Burstall PC presented at Issue Specific Hearing 2 on Wednesday 29th April, on the subject of Landscape and Visual Effect, including cumulative impact, mitigation and residual effects on the village of Burstall. We remain concerned about the lack of engagement, focus and the inadequate responses to the issues we continue to present.

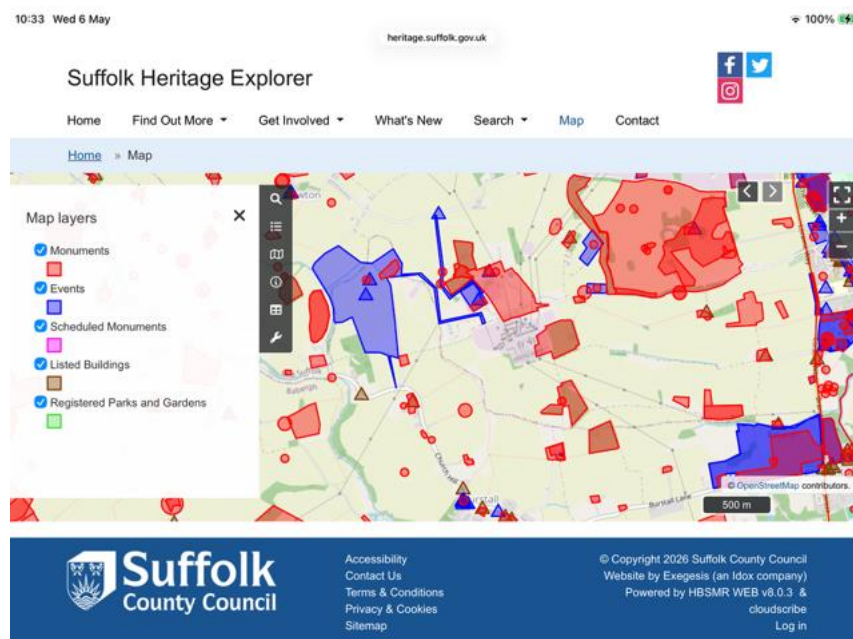
4. App 122, para 6.1.4 - there has been no acknowledgement of the proposed mitigation offered by moving the pylon route east as it travels south from the substation. The contour map clearly shows how even a small move east of a few hundred metres would adjust the pylon route from red to yellow and green contours. Any basic ground survey would identify this simple mitigation measure. Even a small move east would substantially help to reduce the impact to Burstall of the wirescape, as the ground falls rapidly. This would have a large impact on Burstall village preventing the views of pylons over the top of, and in the gaps between, the ancient woodland blocks, acknowledged by NGET.
